28 November 2011

**Re: Response to Seqwater submission "Further response to Mr Babister's hydrodynamic modelling report," dated 21 November 2011**

Figure 1: Option B scenario from Reference 1

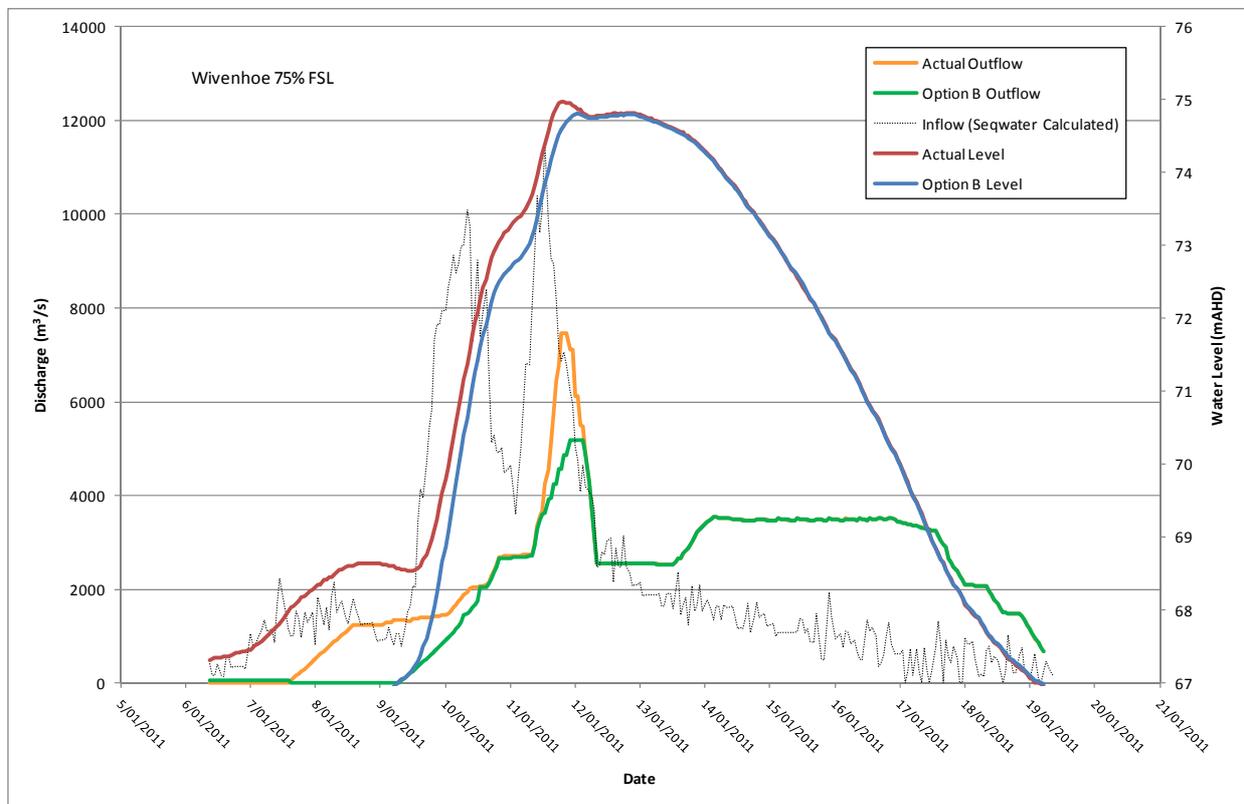
- 3 The discussion presented in the Seqwater submission relates generally to the "Option B" hypothetical scenario assessed in WMAwater's report (Reference 1). The Option B scenario estimated the impact on flood behaviour during the January 2011 flood event, had the storage level in Wivenhoe Dam been at 75% of FSL prior to the commencement of the flood-producing rainfall, rather than close to 100% as actually occurred. The Option B scenario did not consider any changes to the dam operational procedures for flood mitigation.
- 4 Seqwater (via Allens Arthur Robinson) raise the following objection relating to the Option B scenario in their submission:

*We are instructed that Mr Babister's conclusion of a 0.3 metre reduction at the Brisbane Port Office is based on an assumption that Strategy W1 is effectively bypassed. This assumption is evident from paragraph 77.*

*Our client does not agree that this would occur in real time flood operations. Nor is it permitted under the Manual.*

*The effect of this assumption is to overstate the potential reduction in flood levels downstream of Wivenhoe Dam for Option B which are [sic] reported in Mr Babister's report.*

- 5 Bypassing Strategy W1 is permitted under the Manual (Reference 8), as clearly indicated by the flow chart on page 23 of that document, described on page 22 as “showing how best to select the appropriate strategy to use at any point in time.” The flow chart requires that Strategy W1 be bypassed if the Wivenhoe Dam level is “likely to exceed EL 68.5 m” [68.5 mAHD], once a Flood Event has been declared, presumably as a result of the Wivenhoe Dam level exceeding 67.0 mAHD. The criteria for “declaring a Flood Event” are not explicitly stated in the Manual, but there is an implication that this occurs once the dam level enters the flood storage compartment above 67.0 mAHD.

- 6 In the hypothetical Option B scenario modelled by WMAwater, the early part of the flood is contained by the additional 25% of FSL available from the 75% FSL starting condition. The Wivenhoe Dam level rises above 67.0 mAHD at 7:00am on 9 January, at which time the inflow to the dam exceeds 1,000 m<sup>3</sup>/s and is rising quickly to over 7,000 m<sup>3</sup>/s within 12 hours (refer Figure 1).
- 7 At that time when the dam level exceeds 74.0 mAHD, even in the extreme case where the gates are opened according to the minimum intervals specified in the Manual, the level in Wivenhoe Dam could not have been kept below 68.5 mAHD. With the maximum outflows specified by Strategy W1, it would have been impossible to keep the Wivenhoe Dam level

below 68.5 mAHD. The operator would therefore have been required to bypass Strategy W1 according to the flow chart on page 23 of the Manual.

- 9 WMAwater therefore reaffirm that under the hypothetical Option B scenario, it is appropriate to assume that “Strategy W2 would have been engaged almost immediately,” as per Paragraph 77 of Reference 1. WMAwater consider that the estimated impacts reported for the Option B scenario are not overstated as suggested by Seqwater.

Figure 2: Seqwater outflow scenarios for 75% of FSL, using Revision 9 of the Manual

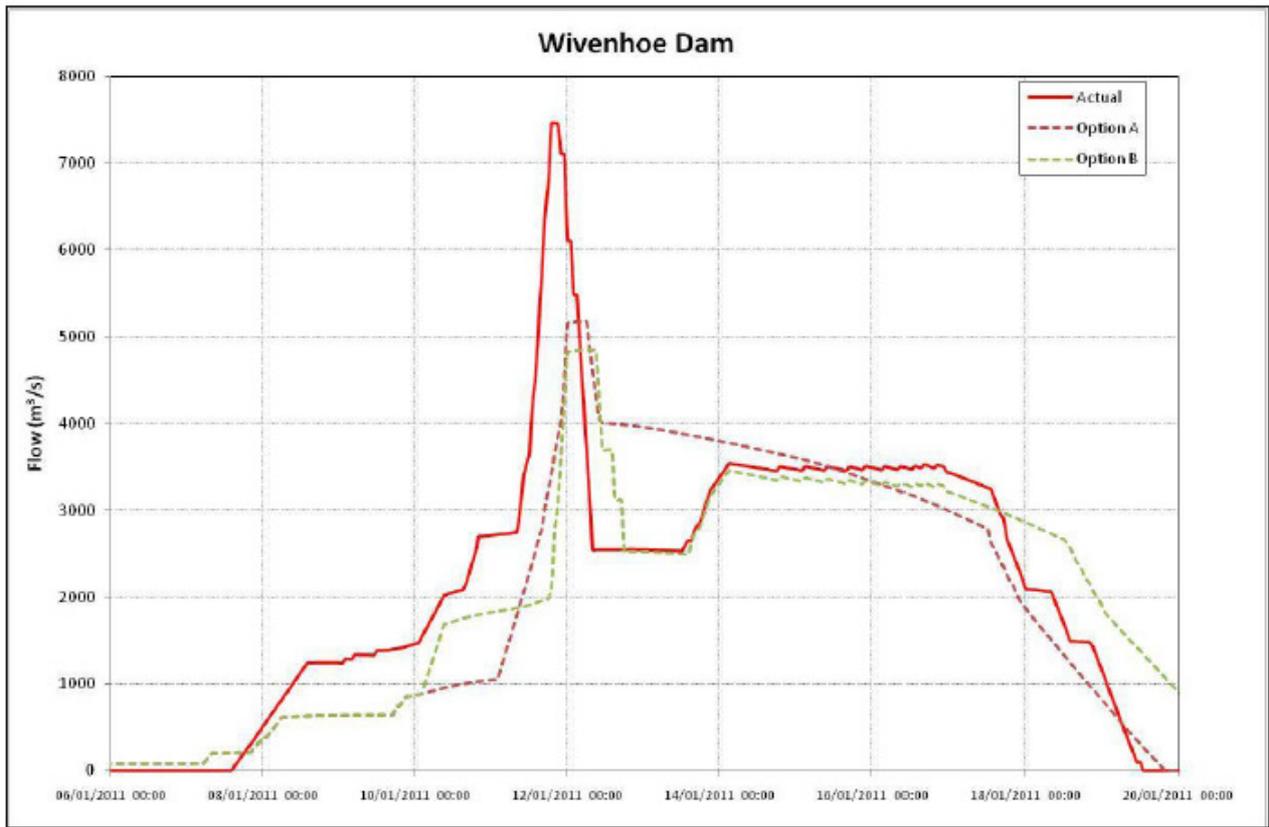
*In summary, the modelling suggests that if a flood event similar to January 2011 was experienced in the future, a reduction in water storage to 75% of FSL prior to the commencement of the event with a commencement of flood releases at that level, could reduce the flood level at the Brisbane Port Office by between 0.2 metres and 0.4 metres.*

*The reduction in flood level of 0.4 metres assumes an aggressive approach to maximising river flows within the allowable limits of the Manual. We are instructed that it is unlikely such an approach would be adopted by a responsible flood engineer in real time. The reduction of 0.2 metres assumes a less aggressive approach that is more likely to be adopted in real time.*

- 23 WMAwater have not made a detailed assessment as to whether the Seqwater dam outflow scenarios (Figure 2) for compliance with Revision 9 of the Manual. However it is observed that the scenarios in the Seqwater submission do not retain the Wivenhoe Dam level at near FSL (67.0 mAHD) at the conclusion of the flood event, as per Section 3.5 of Revision 9 of the Manual. This factor is not considered to significantly impact the outcomes of the modelling undertaken for these scenarios, which have been focused on peak flows and flood levels.

- 13 The Commission requested that WMAwater undertake independent modelling of the scenarios presented by Mr Malone in the Seqwater submission. WMAwater do not have access to the working of Mr Malone, and have endeavoured to reproduce the outflow sequences shown in Figure 1 and Figure 2 of the submission, although inevitably there are some minor differences. The outflow sequences from Seqwater and reproduced by WMAwater are shown in Figure 2 and Figure 3 respectively, below.

- 17 The results obtained by WMAwater are very similar to those obtained by Seqwater. The minor differences can most likely be attributed to differences in the Wivenhoe Dam outflow hydrographs, which were derived independently by WMAwater based on visual inspection of the chart in the Seqwater submission (refer to Figure 2 and Figure 3). WMAwater consider that these results are essentially equivalent to those provided in the Seqwater submission, as the differences in estimated flood level impacts are within the likely bounds of modelling error associated with those estimates.
